Request For Information

Project: Monroe Library **RFI #:** 31
A/E Project # B-99-01-12 **Date:** 8/21/2012
TO: Lori Stephens - Broadleaf Architecture **Requested Response Date:** 8/21/2012
From: Ed Vaughn - 2G Construction **Trade:** Rough Carpentry
Initiated By: Ed Vaughn - 2G Construction **Subject:** Termite damage @ existing floor joists

SK-1

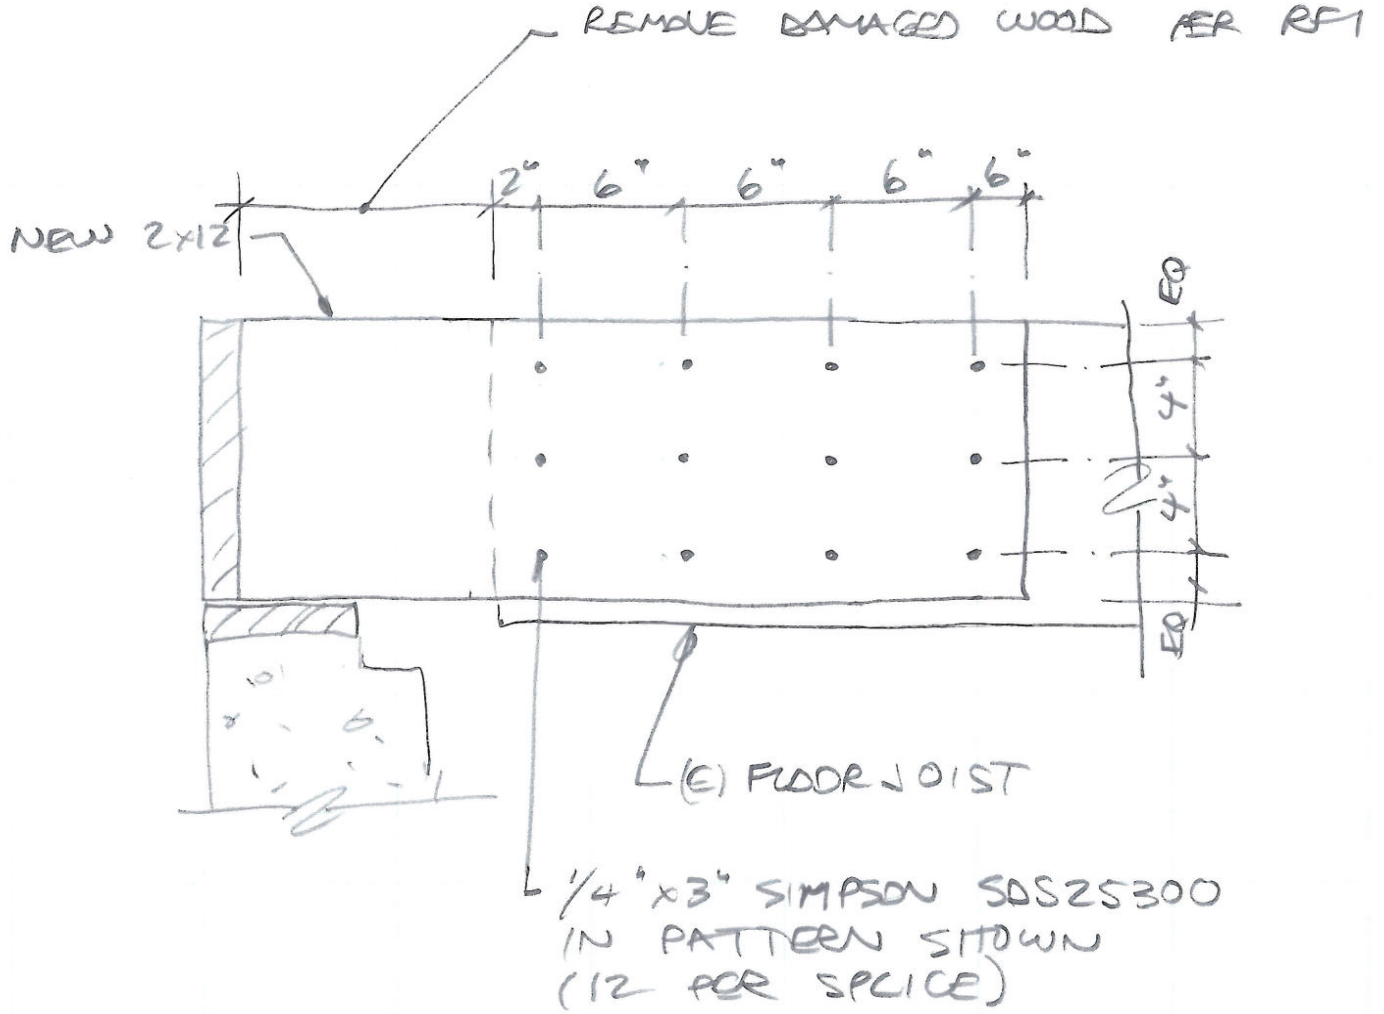
Item #	Description
1	We discovered some termite damage to the existing floor joist in the train depot at the South and North end of the structure. Please provide a detail to laminate new floor joist to the existing that will extend to the South rim joist. See attached pictures. Cut out portion of joist will be the following: 1 @ 3", 1@ 8 1/2", 2 @ 15", 1 @ 18", & 1 @ 42". The East & West rim joist have an existing splice @ 8' and sit entirely on mud sill. The first existing beam is 8' back from South rim joist.

Item #	Response:
1	Shore joists and remove damaged material. Splice new 2x12's as per enclosed detail SK-1 with Simpson SDS25300 screws. Install/splice rim joist per nail lam notes in drawings.
